Fairfield

Post Road (CT Route 130) – Road Safety Audit

June 22, 2016

Figure 9. Overgrowth narrowing sidewalk

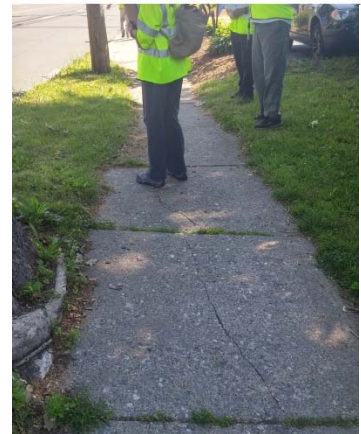
- The sidewalk on the south side of Post Road is narrow (Figure 8).
 - Becomes even narrower in some locations where there is overgrowth on the sidewalk (Figure 9).

- a. Paint no parking hash marks where customers park in areas that are not designated spaces in the parking lot opposite Riverside Drive (Figure 18).
3. Sidewalks:
 - a. Clear overgrowth on sidewalks and maintain branches that encroach on sidewalk space.
 - b. Repair damaged sidewalk areas (Figure 19).
4. Add new bike racks along Post Road at popular destinations.
 5. Remove one or two parking spaces on Grasmere Avenue at street corners for bus route stops.
 6. Perform a road diet study on Post Road.

Figure 20. Short term recommendations map

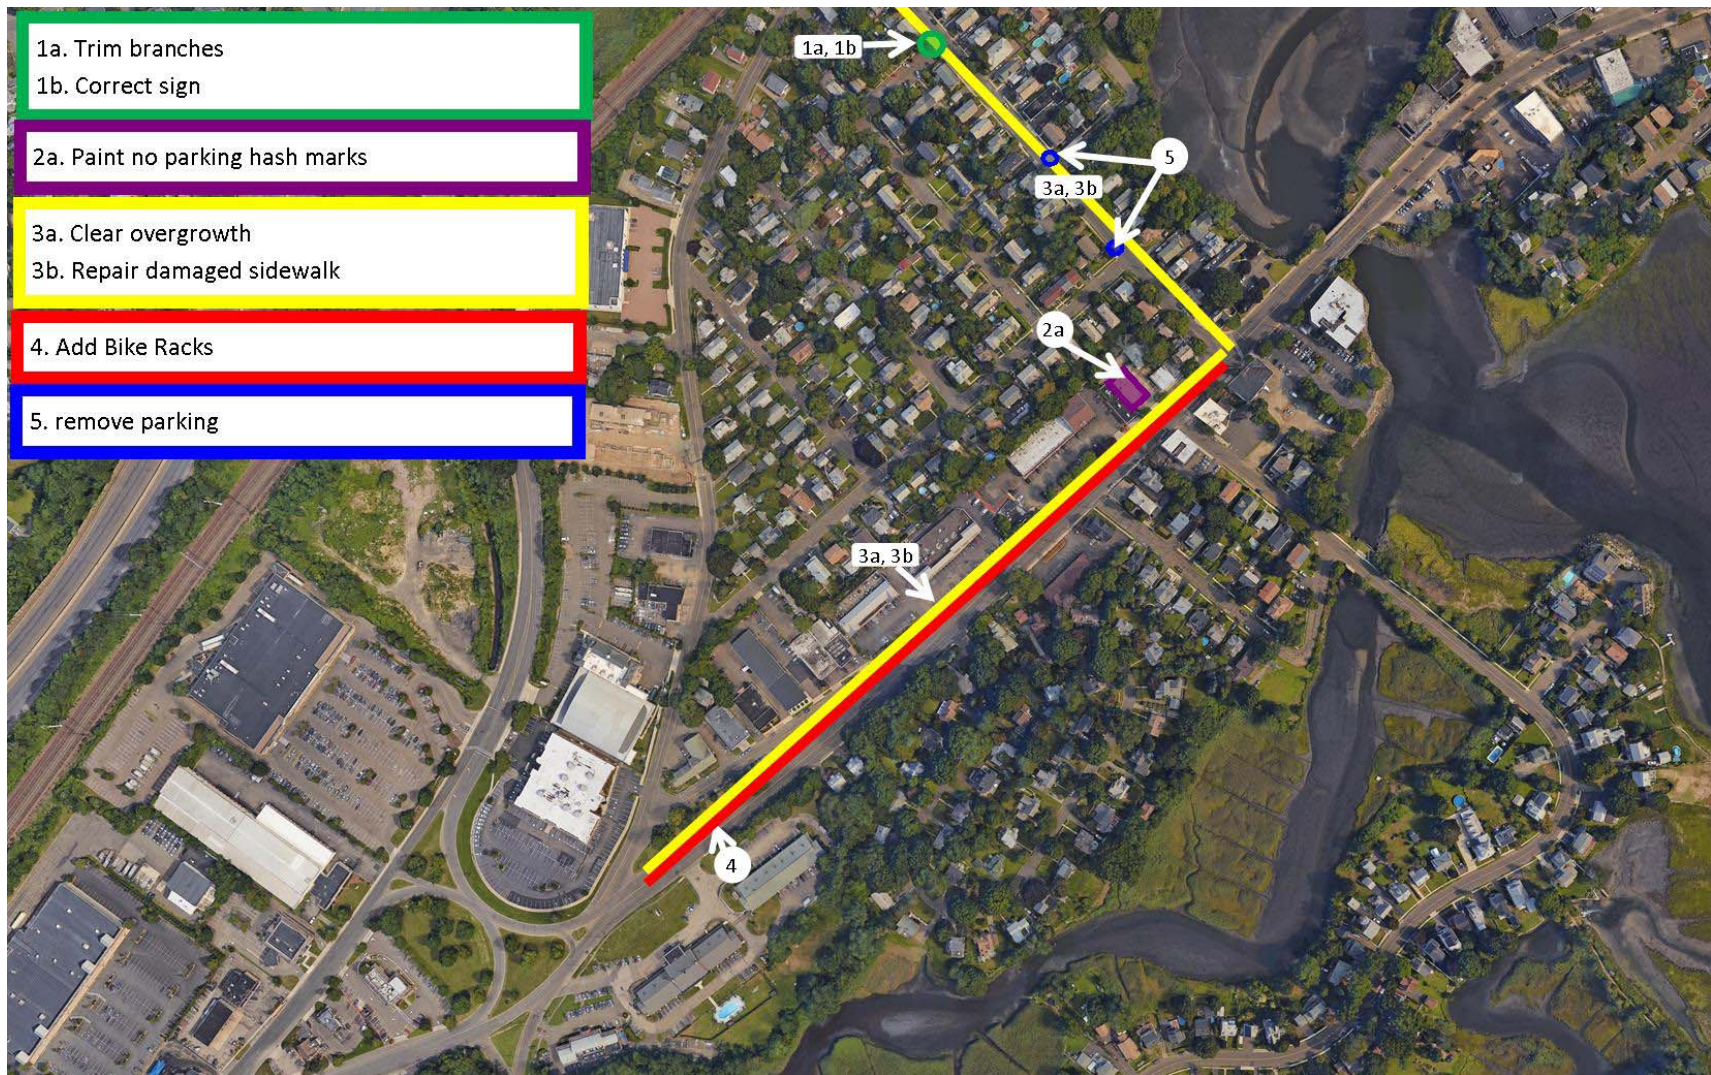
1. Signage:
 - a. Trim branches in front of one way sign on Plum Street.
 - b. Correct one way sign on Plum Street that is facing the wrong way.
2. Pavement Marking:

Figure 24. Medium term recommendations

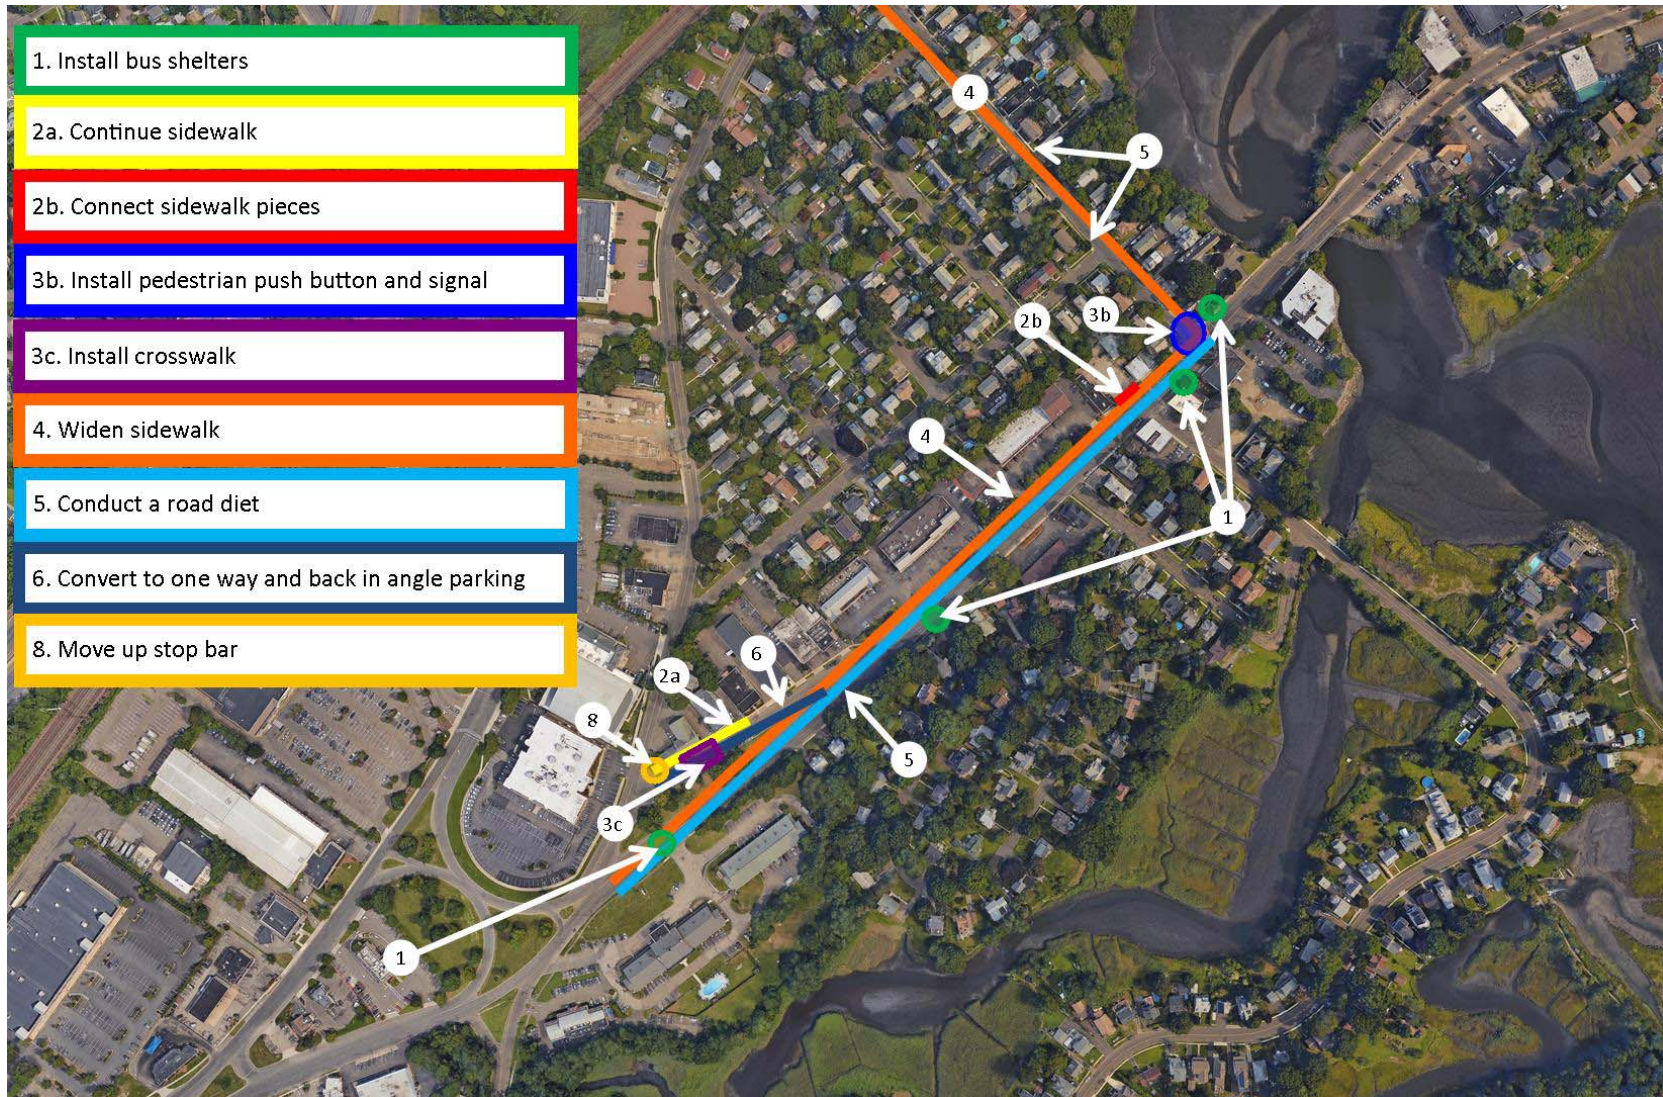
1. Install shelters at bus stops along the corridor.
2. Sidewalk network:
 - a. Continue sidewalk on Post Road Jug Handle from Physical Synergy to businesses further west on the street.

- b. Connect sidewalks on both sides of the entrance to the parking lot opposite Riverside Drive. This could mean installing a sidewalk, using an alternate textured material or simply painting a crossing.

3. Crosswalks:
 - a. Replace sidewalk ramps and/or add detectable warning strips to ramps where needed (Figure 21).
 - b. Coordinate with CTDOT to install pedestrian push button and signal for the Grasmere Avenue crossing at Post Road.

- c. Coordinate with CTDOT to install a midblock crosswalk on the Post Road Jug Handle in conjunction with a bus stop placement study.
4. Widen sidewalks where possible.

5. Conduct a road diet on Post Road by restriping one travel lane in each direction with middle shared left turning lane (Figure 22). Consider striping a bike lane with the extra street space.

6. Convert Post Road Jug Handle to one way travel and restripe for back in angled parking instead of parallel parking (Figure 23).
7. Ensure that bike friendly catch basins with smaller grates are installed along with pavement projects.

8. Move up stop bar at the intersection of Post Road Jug Handle and Kings Highway.

Figure 27. Long Term recommendations map

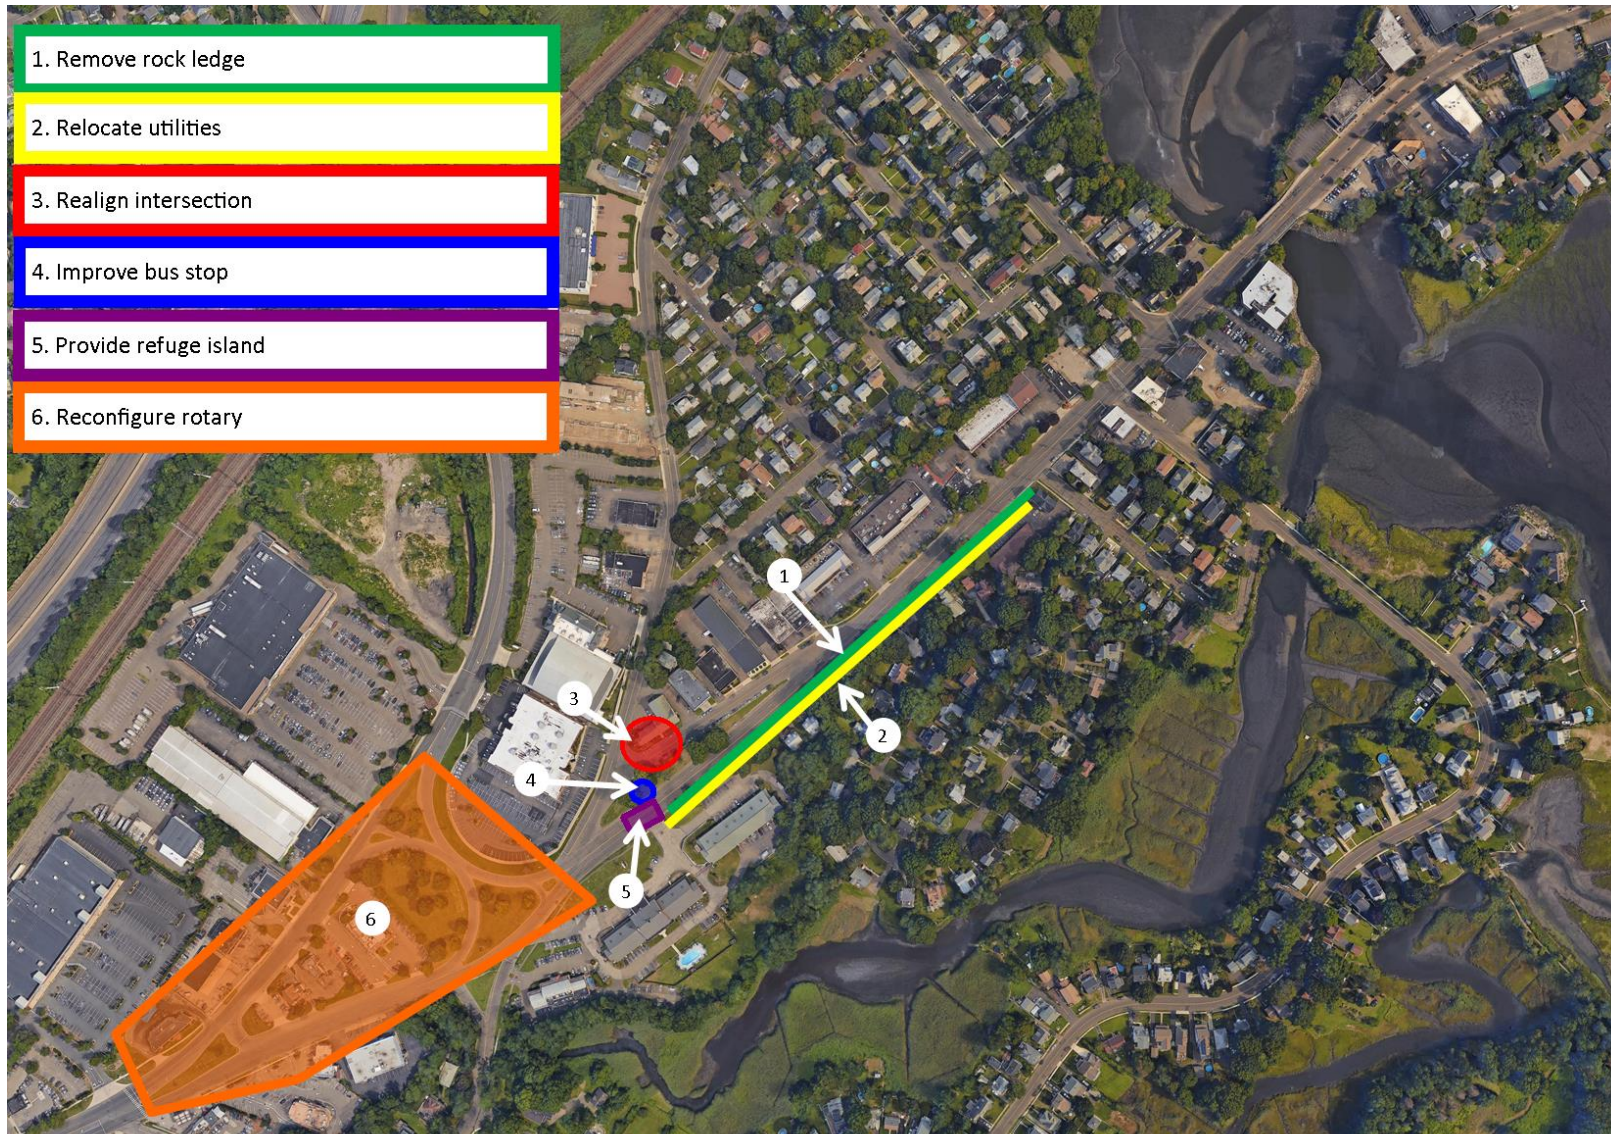
1. Remove some of rock ledge on south side of Post Road to make room for widening the sidewalk to five feet. It is noted that there may be right of way implications.
2. Relocate utility poles on the south side of Post Road from the middle to the back of the sidewalk. Relocating utilities underground is an option but would be very costly.
3. Realign the intersection of the Post Road Jug Handle and Kings Highway by squaring off intersection and reducing curb radius.
4. Improve bus stop on the Jug Handle Island across from the Fairfield Circle Inn by installing a shelter and cutting into severe slope (Figure 25).
5. Provide a refuge island for pedestrians crossing between the bus stop on the Jug Handle Island and the Fairfield Circle Inn (Figure 26).
6. Reconfigure the rotary where Post Road meets U.S. 1
 - o Check for 345 KV lines that may be underground
